Determination 2006/104

Access for people with disabilities to the Mt Victoria / Matairangi Summit Lookout, Wellington

Figure 1: The proposed stepped route

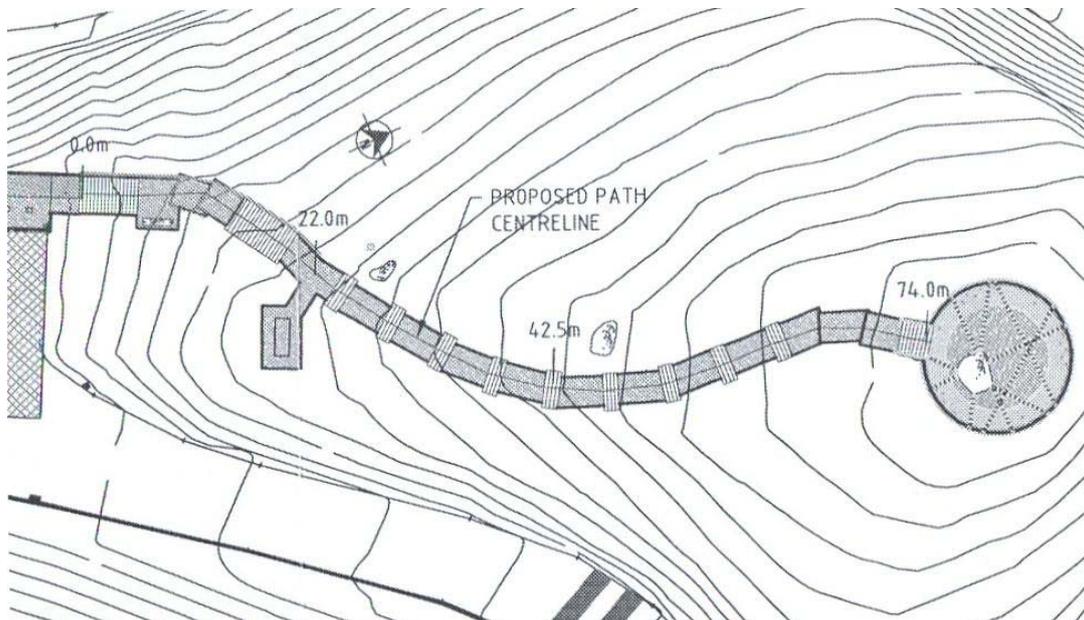
- 2.2 The lookout is to be enlarged as part of a general upgrading to make the area a more attractive and interesting place to visit. The lookout will be a concrete viewing platform with glassed balustrades. The upgrading will include the provision of two accessible car parks adjacent to the Byrd Memorial. The territorial authority proposes to provide stepped access from the accessible car parks to the lookout.

- 2.3 The lookout is approximately 16 m higher than the accessible car parks. The proposed stepped route between them is approximately 74 metres long. An accessible ramped access route would need to be approximately four times as long, almost 300 metres, and would also involve extensive additional earthworks. An inclined wheelchair lift from the road to the lookout is estimated to cost approximately \$300,000.

- (a) The proposed stepped route, although not useable by people in wheelchairs, would improve access for people with ambulant disabilities.
- (b) To iwi this is a significant cultural site, so it is important for the development to "touch the summit lightly".
- (c) There are other lookouts in the area that are accessible and provide comparable views.

- (a) The stairs and handrails of the proposed stepped access would be suitable for people with ambulant disabilities.
- (b) A waiver was sought only for “clause D1.3.4 subparts (a) to (e) inclusive”.
- (c) “Cost is not the only consideration in our application for a waiver. The costs of a fully accessible walkway although not costed are likely to be less than the chair lift option. However, there are significant cultural and landscape issues . . . which were the drivers behind our application for a waiver.”
- (d) “. . . the incorporation of ramped access, even at steeper grades, is not feasible or practical.”

6.1 In accordance with sections 69 and 188(1) of the Act, I hereby grant a waiver of clauses D1.3.4(a) to (e) inclusive in respect of the access route between the accessible car parks and the lookout, provided that the stepped access is to comply with the requirements of D1/AS1 for accessible stairs.

Figure 2: The accessible ramped route

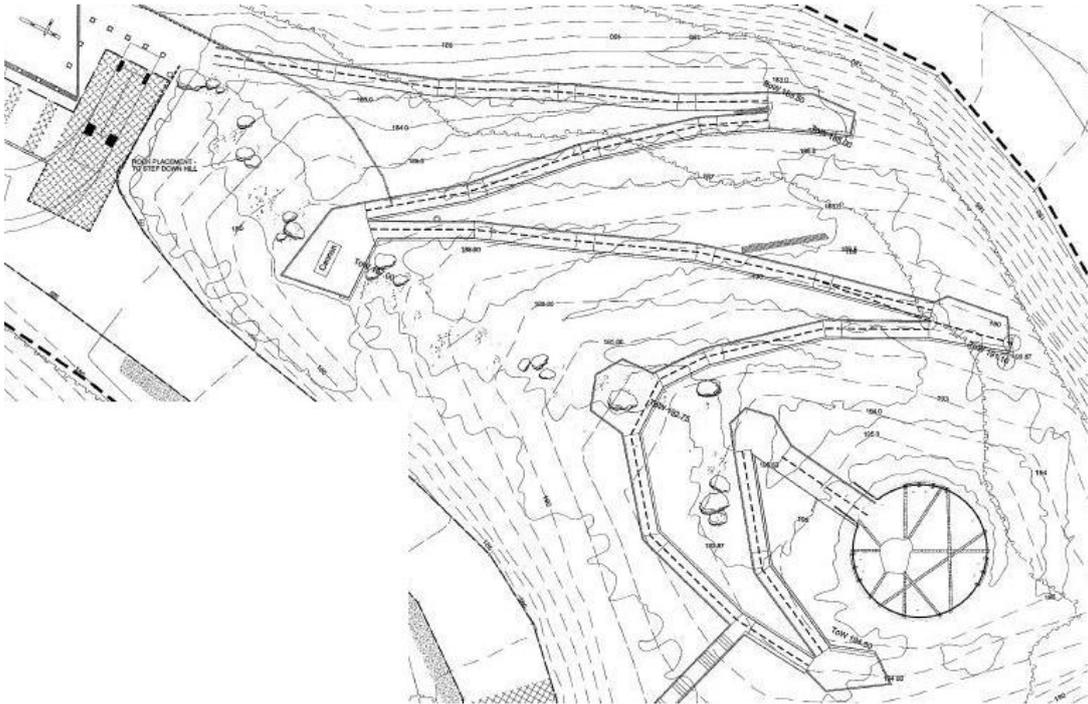
- 5.3.4 The accessible ramped access shown in Fig. 2 above (which incorporates a stepped “short-cut”) is approximately 290 m long whereas the proposed stepped access is approximately 74 metres long. Determinations 94/004 and 96/004 discussed the length of accessible ramped routes in comparison with stepped routes. Admittedly those determinations were essentially considering whether it would be reasonable to require lift access, but they tend to indicate that in this case the ramped access route is not a reasonable solution on the grounds of its length. Be that as it may, I consider that it would not be reasonable to require accessible ramped access because:

- (a) The capital cost is approximately the same as for lift access (although with lower maintenance costs).
- (b) As shown by Fig. 2, accessible ramped access would have a very significant effect on the landscape of the summit, which was a cause of concern to iwi, see 4.1 above. This is not simply a matter of visual experience, as discussed in Determination 92.1102, but a matter of cultural importance.

- 5.3.5 The ODI favoured ramped access but at a steeper slope than the 1:12 specified in the compliance documents so that wheelchair users could use it with appropriate assistance. The territorial authority responded that such a solution “is not feasible or practical”.

- 5.3.7 The compliance documents specify 1:12 as the maximum slope for an accessible ramp. The acceptable solution for access in general, F1/AS1, specifies 1:8 as the maximum slope for a “common ramp normally dry”, with 1:3 acceptable for a “service ramp” ramp incorporating footholds. Assuming, for the sake of argument, that a slope of 1:8 would be useable and safe for assisted wheelchair users, increasing the slope to 1:8 can be considered to reduce the length of the route by approximately one-third (ignoring landings). That would significantly reduce both the cost and the effect on the landscape. However, both the cost and the effect on the landscape would still be much larger than for the proposed stepped access.

5.3.10 Accordingly, balancing costs against benefits, I consider that it would not be reasonable to require either lift access or ramped access in this case.

Figure 3: The accessible wheelchair lift

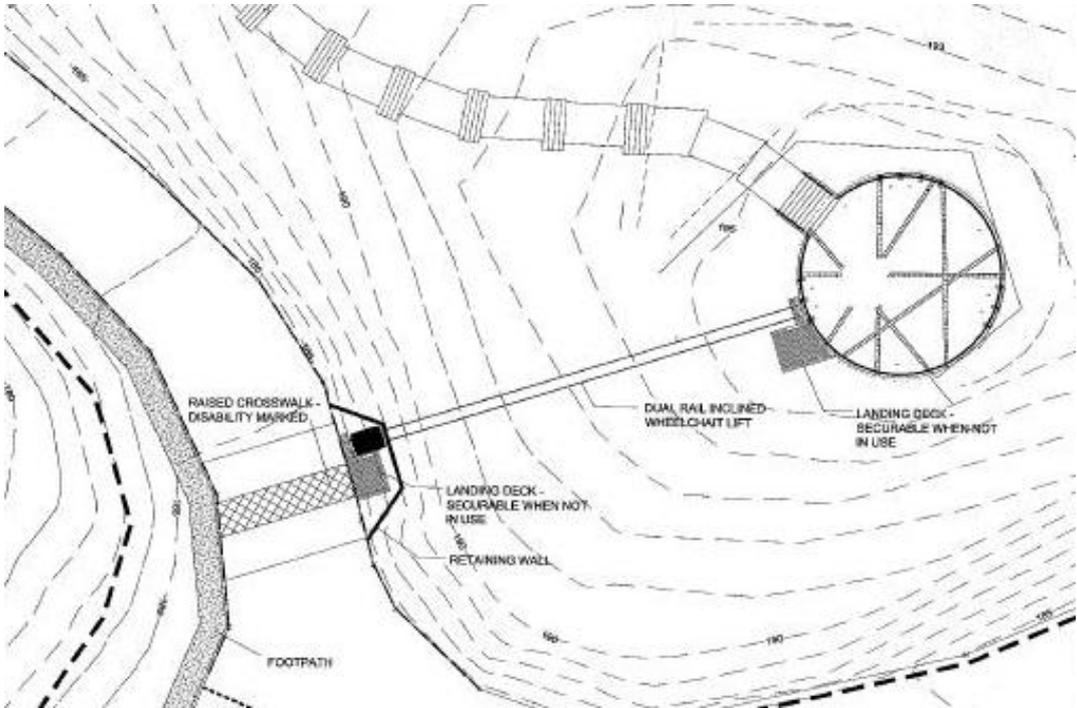
- 5.3.1 The wheelchair lift shown in Fig. 3 above is clearly the ideal solution but very expensive at approximately \$300,000 plus significant annual maintenance costs. The territorial authority’s consultations revealed no support for lift access. I conclude that, on grounds of ongoing cost alone, it would not be reasonable to provide lift access (although it will need to be reconsidered in any future alterations to the lookout).

The cost of full access appears to be quite modest when one considers . . . that it is likely to cost less than about \$2 per citizen of Wellington for a permanent low-maintenance facility that will likely last forever and enable all people, for generations to come, to have easier access than at present.

- 5.3.3 I take the view that the cost of upgrading must be considered in relation to the benefit achieved not in relation to the ability of the owner to meet that cost. In any case, I do not accept that public spending can be justified on the grounds that the cost per head is small or insignificant. Furthermore, \$2 per head of population is several times that per ratepayer, and I do not think that the territorial authority could impose a corresponding increase in everyone’s rates without encountering significant criticism. See also paragraph 5.3.9 for the benefits concerned.
